TIE-LINE 637 WOOD-TO-STEEL PROJECT
MINOR PROJECT REFINEMENT
REQUEST FORM

Date Requested:	June 25, 2014	Report #:	012
Date Approved:	July 1, 2014	Approval Agency:	No other agency approval is required.
Property Owner(s):	Private and SDG&E Right-of-Way (ROW).	Location/Milepost:	SS-15A, SS-15B (near P105) and anchor block near P102
Land Use/Vegetative Cover:	The proposed impact area occurs within disturbed coastal sage scrub habitat.	Sensitive Resources:	Sensitive habitats including native species within disturbed coastal sage scrub.
Refinement / Modification From (check all that apply):			
<input type="checkbox"/> Permit	<input type="checkbox"/> Plan/Procedure	<input type="checkbox"/> Specification	<input type="checkbox"/> Drawing
<input checked="" type="checkbox"/> Other: Stringing Site Modifications			
<p>San Diego Gas & Electric Company (SDG&E) is proposing the following activities that were not originally described within SDG&E's application for a Permit to Construct (PTC) for the TL 637 Project (refer to Proponent's Environmental Assessment [PEA] Appendix 3-B) and the Final Initial Study/ Mitigated Negative Declaration (IS/MND) (see Figure 1 and refer to MND Attachment A): (1) u

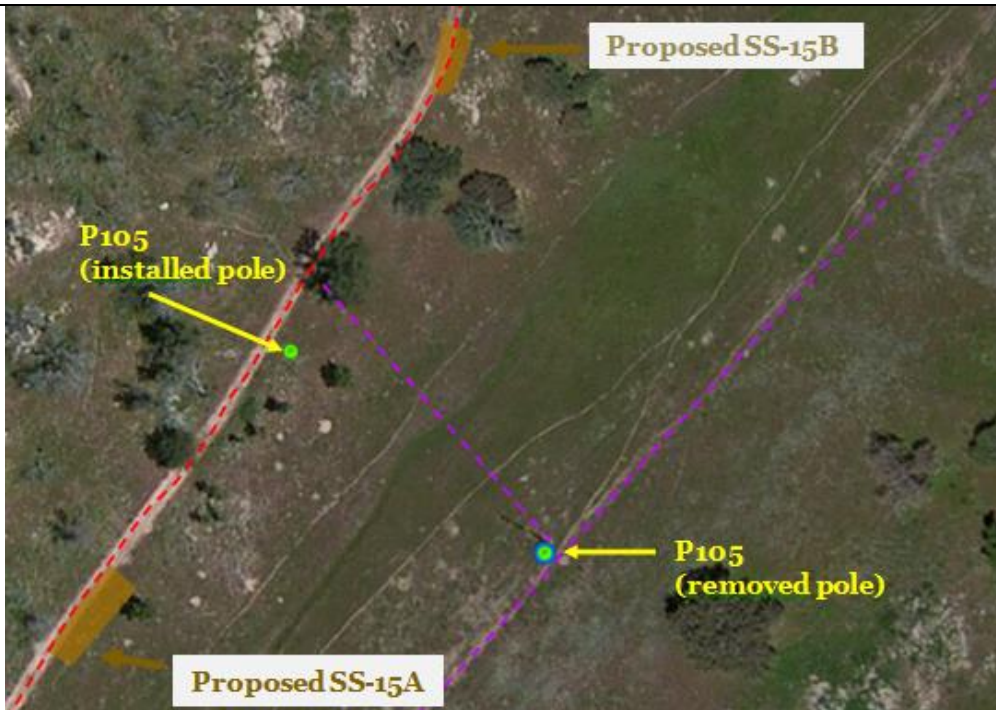
Description of Refinement			
<p>SDG&E proposes to utilize new additional temporary workspace areas near P105 (SS-15A and SS-15B) and temporarily place a block anchor near Structure No. P102 in order to safely and successfully conduct stringing activities. The proposed two additional temporary workspace areas (SS-15A and SS-15B) required for stringing activities are located directly adjacent to the existing main access road near Structure No. P105. The proposed temporary installation of a block anchor occurs off the existing main access road, west of Structure No. P102. Access to all the proposed temporary workspace areas will be from existing approved project access roads.</p> <p>The new SS-15A area is a rectangular shape located adjacent to the main access road west of Structure No. P105 and will result in approximately 1,840 square feet of temporary impacts to disturbed coastal sage scrub habitat. The new SS-15B area is also a rectangular shape adjacent to the main access road east of Structure No. P105 and will result in approximately 1,050 square feet of temporary impacts to disturbed coastal sage scrub habitat. The location for the placement of a block anchor occurs approximately 60 feet west of Structure No. P102 on the north side of the main access road and will result in 36 square feet of temporary impacts to disturbed coastal sage scrub habitat. For a summary of the temporary workspace areas described, see Table 1. The three proposed temporary workspace areas would result in a combined 2,926 square feet of temporary impacts.</p> <p>Figure 2a depicts the proposed new temporary workspace areas for SS-15A and SS-15B near Structure No. P105. Figure 2b depicts the proposed new temporary workspace area required for the installation of a block anchor near Structure No. P102. Photograph Nos. 1 and 2 depict the proposed new temporary workspace at SS-15A and SS-15B, respectively. Photograph No. 3 depicts the proposed new location for the installation of a block anchor near Structure No. P102.</p>

Following in-field review of the stringing sites, construction crews identified potential logistical concerns and determined that additional sites and minor modifications were required to safely and successfully conduct stringing activities. These sites and/or modifications include the new SS-15A and SS-15B temporary workspace areas and the temporary workspace area required for the temporary installation of a block anchor near Structure No. P102, as the areas are more conducive to the proposed work.
